DATE 02.13.23
 PROJECT NO. 2154
 PROJECT WEST FIELD SR. SEMINARY
 FROM STUDIO 333 ARCHITECTS

This Addendum forms a part of the Contract Documents and modifies the original Bidding Documents dated 01.25.23, as noted below. Acknowledge receipt of this Addendum in the space provided on the Bid Form. Failure to do so may subject the Bidder to disqualification.

This Addendum consists of 1 page and the attached Drawing Sheets S1.20 MEZZANINE FRAMING PLAN, S1.30 ROOF FRAMING PLAN and S2.20 FLOOR AND ROOF FRAMING DETAILS.

MEZZANINE FRAMING PLAN
SCALE: 1/8" = 1'-0"

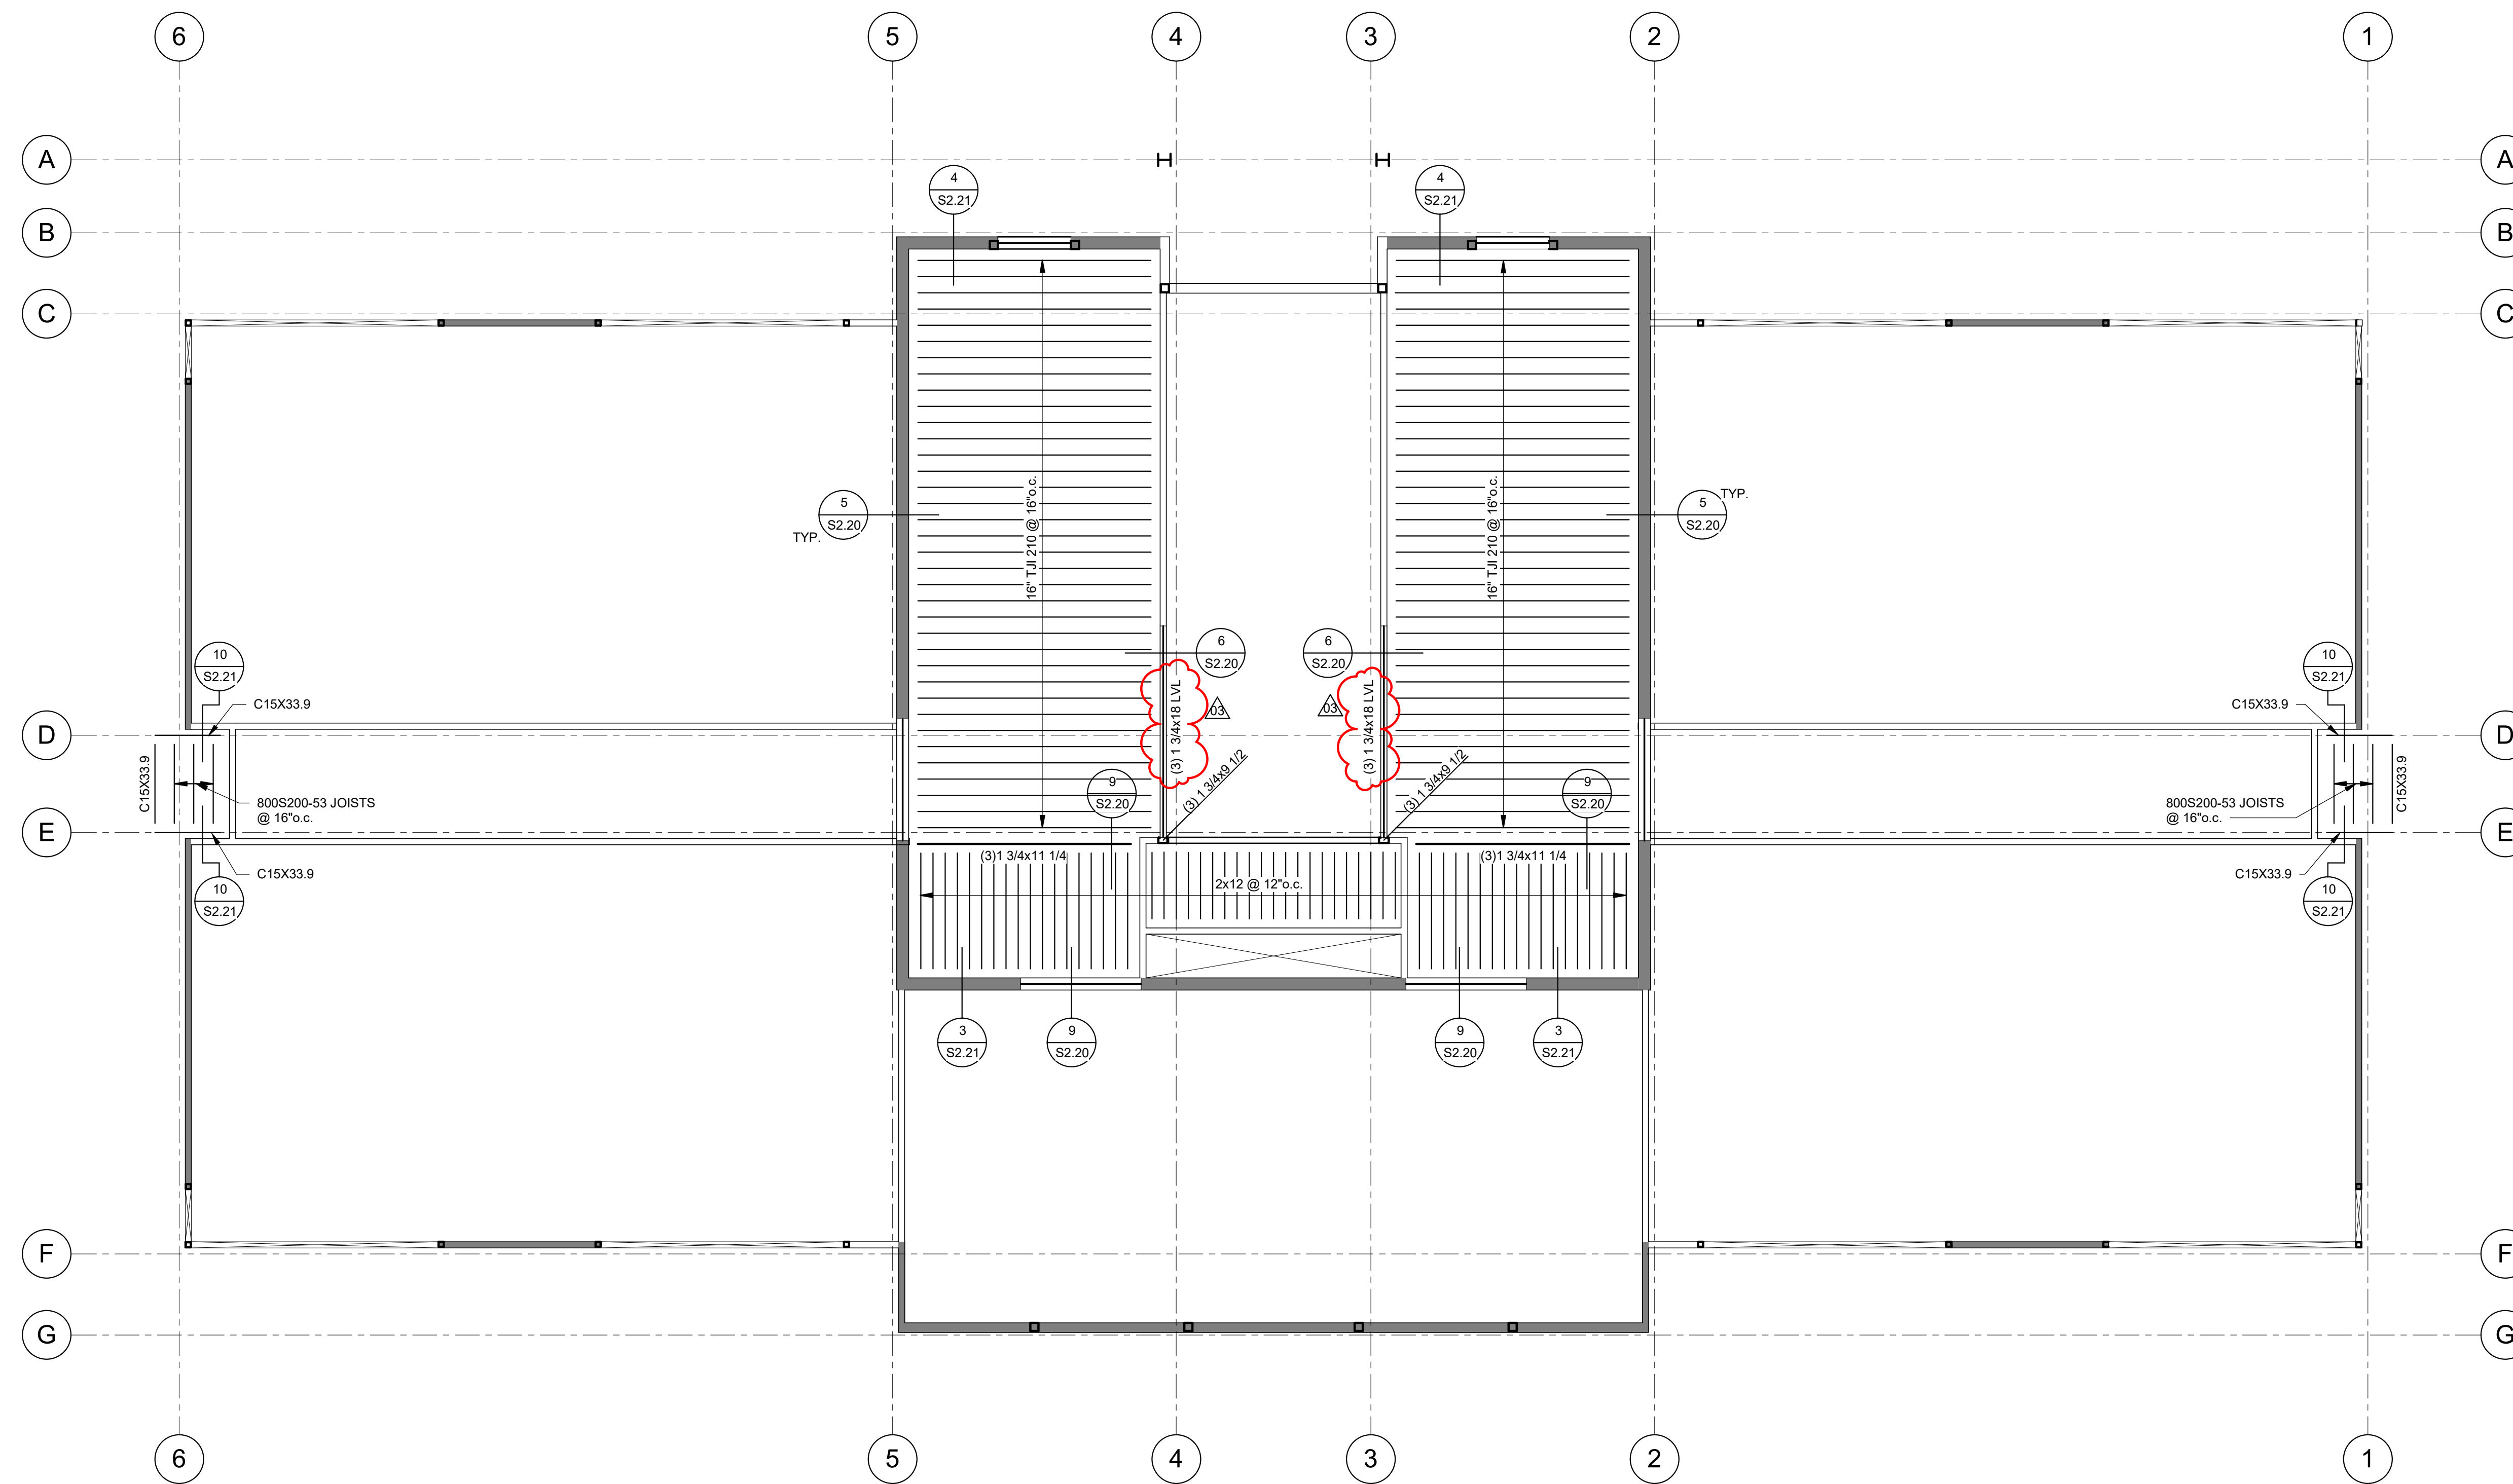
3. Sheet S1.20 MEZZANINE FRAMING PLAN:
 - a. Beams on grids 3 and 4: Updated LVL beams to be 18" deep.
 4. Sheet S1.30 ROOF FRAMING PLAN:
 - a. Detail callouts on grids 3 and 4: Added detail 11/S2.20 callouts on grids 3 and 4 to clarify stud walls are bearing walls for the roof trusses.

11
SCALE: NONE
S2.20

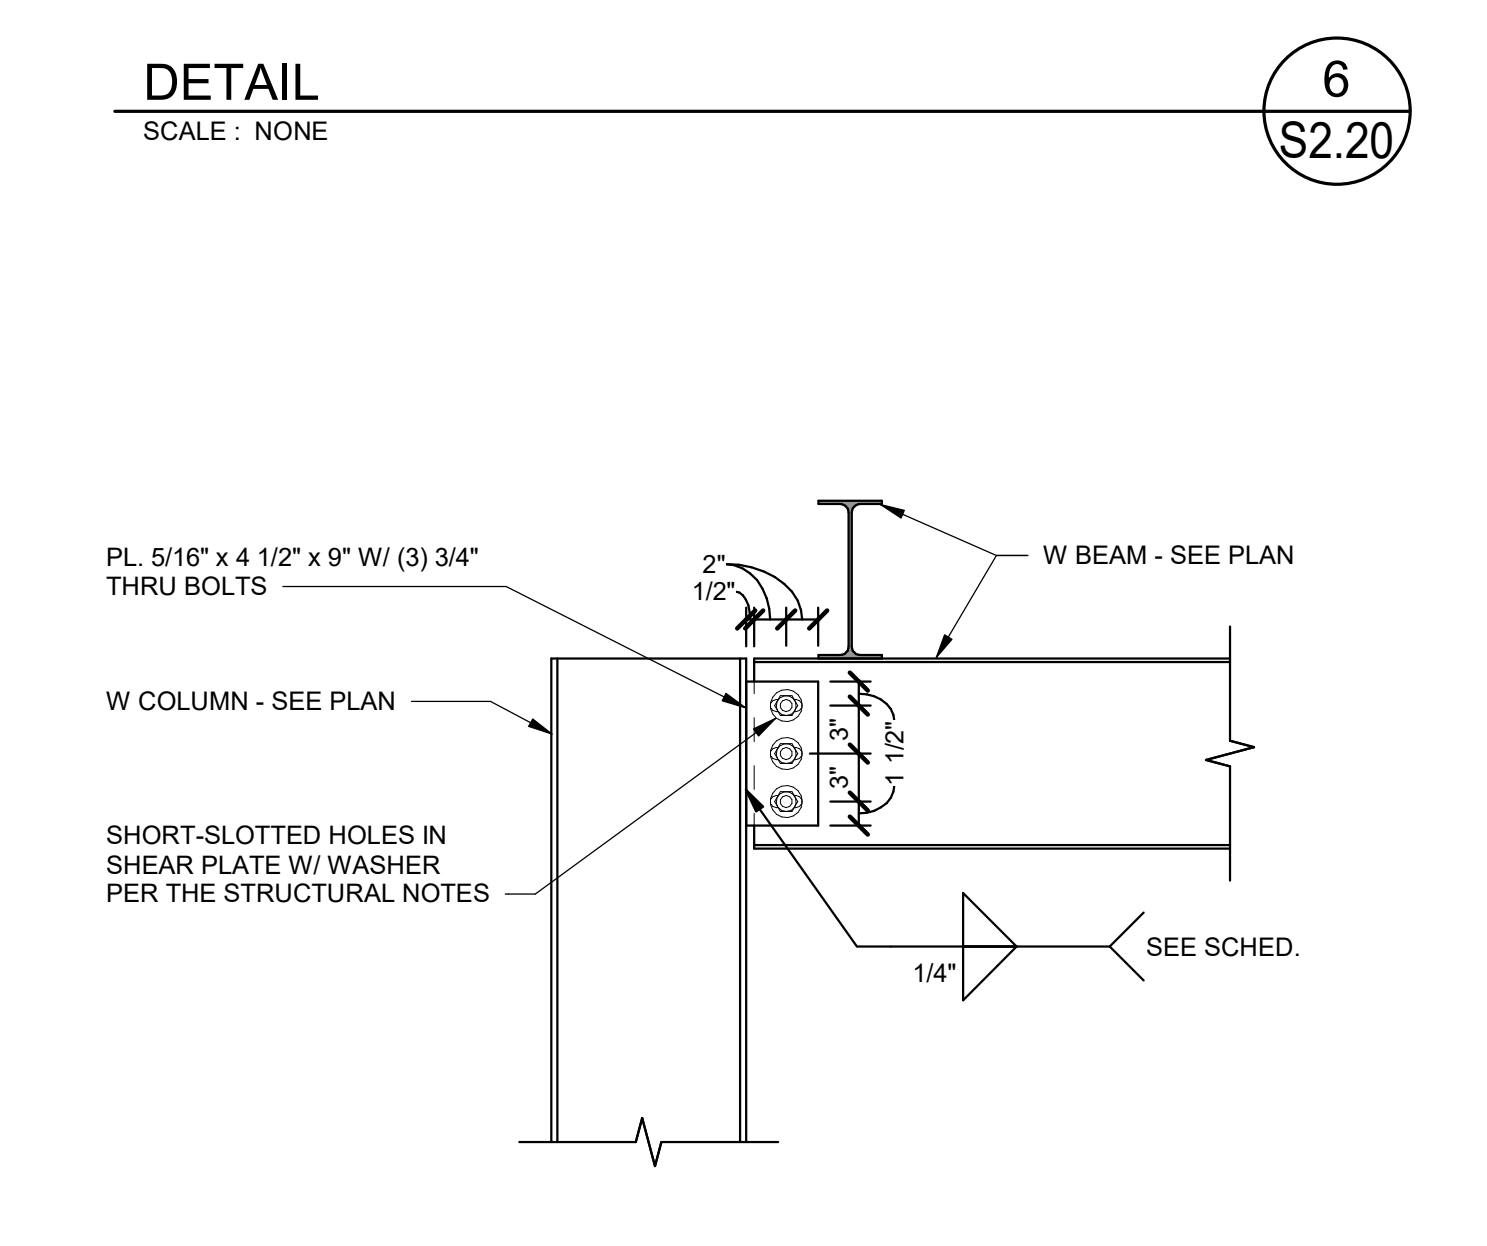
5. Sheet S2.20 FLOOR AND ROOF FRAMING DETAILS:
 - a. Updated detail 6 to clarify wall extends on top of beam.
 - b. Added detail 11 to clarify that roof trusses bear on walls on grids 3 and 4.
